IEEE Standards Interpretations for IEEE Std 1588™-2008 IEEE Standard for a Precision Clock Synchronization Protocol for Networked Measurement and Control Systems

This is an interpretation of IEEE Std 1588-2008.

December 2011

Figure 1 - Message timestamp point on a 100Base-FX frame

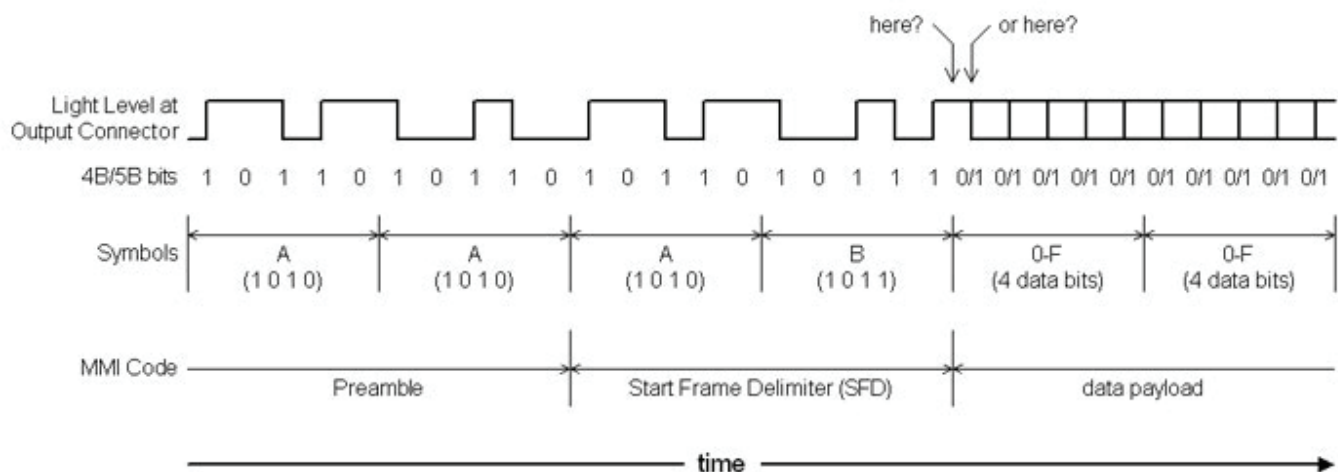
Where precisely is the message timestamp point with PTP over IEEE Std 802.3 /Ethernet 100Base X?

Clause 7.3.4.1 states that "... the message timestamp point for an event message shall be the beginning of the first symbol after the Start of Frame (SOF) delimiter." Presumably the timestamp point is thus the beginning of the first bit of this first symbol. However, 100Base-X uses NRZI, wherein where a polarity transition represents a logical ONE, and the absence of a polarity transition denotes a logical ZERO. Is the start of the first bit the point where a polarity transition would occur should there be one, or mid-way between the point where a polarity transition would occur in the first bit should there be one and the transition of the previous bit?

This is important as the time difference between these two points is 4 ns, much more the PTP synchronization accuracy better than 1 ns claimed in the scope.

Clause 7.3.4.1 as noted defines the message timestamp point as the beginning of the first symbol after the start of frame delimiter. Clause 7.3.4.2 states that the timestamp is referenced to the point where the message timestamp point passes the clock reference plane that marks the boundary between the clock and the network and illustrated in Figure 19. For Ethernet this reference plane should be interpreted as a point on the physical media side of the PHY and therefore the question of symbol and bit boundaries in the on-the-wire encoding is important. These encodings are not specified by IEEE Std

Therefore in the figure provided by the questioner the message timestamp point is the choice on the right.
